# REDSTONE GATEWAY EXTENSION, MARKET STREET AND OVERLOOK ROAD RELOCATION PACKAGE 1F-4 – LANDSCAPING AND IRRIGATION Project No. 65-11-SP22 April 23, 2012

# Addendum #3

Attachment: Sidewalk Limits Sketch
Revised Irrigation Specifications

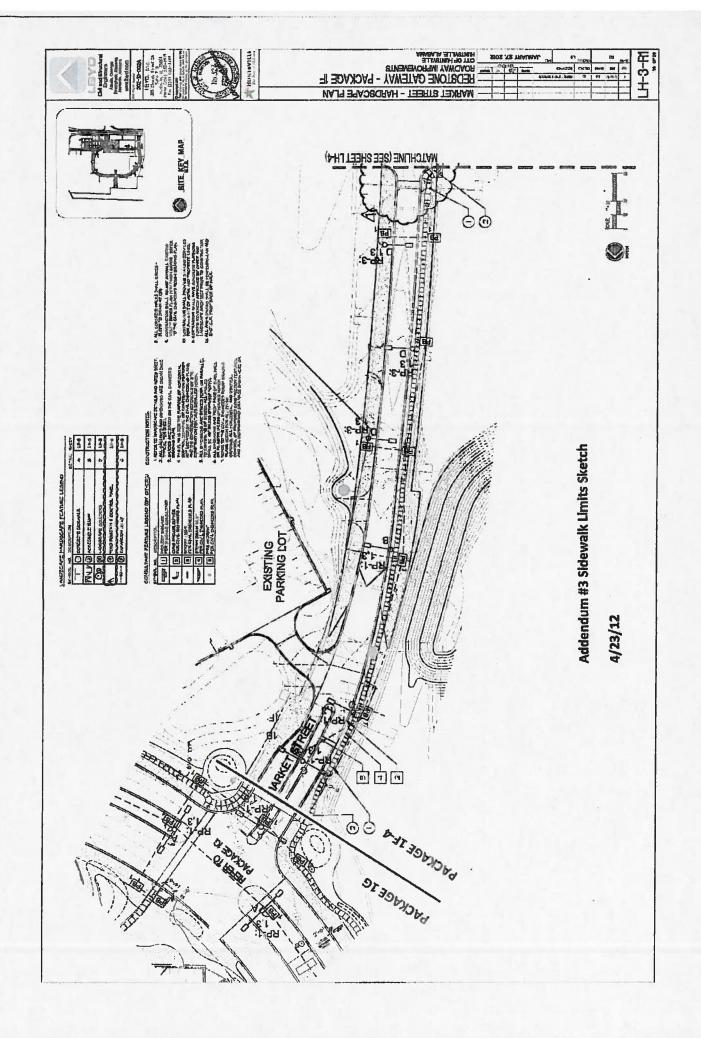
- 10. Q. We would like to request that Ray Bracken Nursery, Plantation Tree Farm, and Green Valley Farms be added to the approved nursery list.
  - A. Ray Bracken Nursery and Plantation Tree Farm are approved nurseries. However Green Valley is only an approved nursery for plants and groundcover only no trees.
- 11. Q. The plant schedule calls for <u>Ilex</u> x 'Burford' (tree form), but lists Emily Bruner Holly as the common name which holly are we to use?
  - A. The Landscape Architect is looking for any variety of holly that is multi-stem that matches the specifications and matches what is on site now.
- Q. Where does the sidewalk in Package 1G stop and 1F-4 sidewalk begin on Sheet LH3-R1?
   A. The sidewalk for Package 1F-4 on sheet LH-3-R1 starts at the crosswalk on the north end of Market Street per the attached sketch.
